1966 Corvette: Service Bulletin: Air Pump Noise - Air Injection Reactor System

Bulletin No: TSB #66-62

Date: May 20, 1966

Date Code

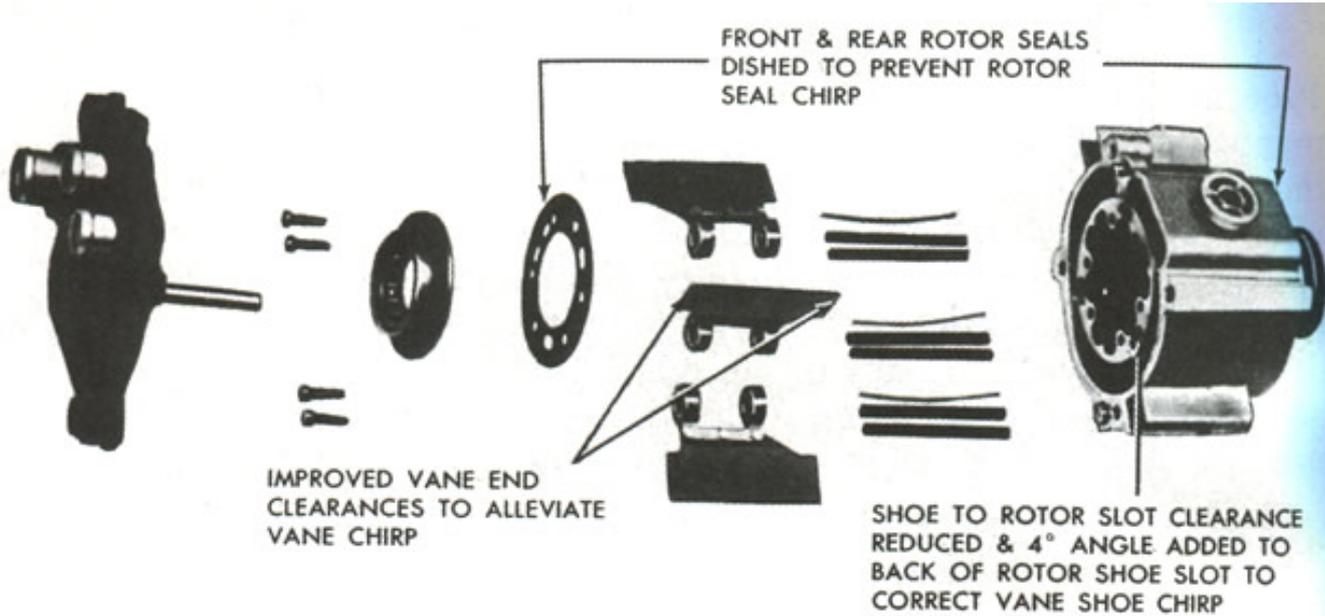
In production, beginning with date code 0126XX stamped on the pump housing, improvements have been incorporated as noted on page 2, to alleviate the above conditions.

If upon completion of the above, the "chirp" still persists, or if the "chirp" is heard at higher pump speeds, the entire pump assembly must be replaced with a pump having a date code of 0126XX or later. Control of pump service components is such that there is no identifying feature to indicate the latest improvements.
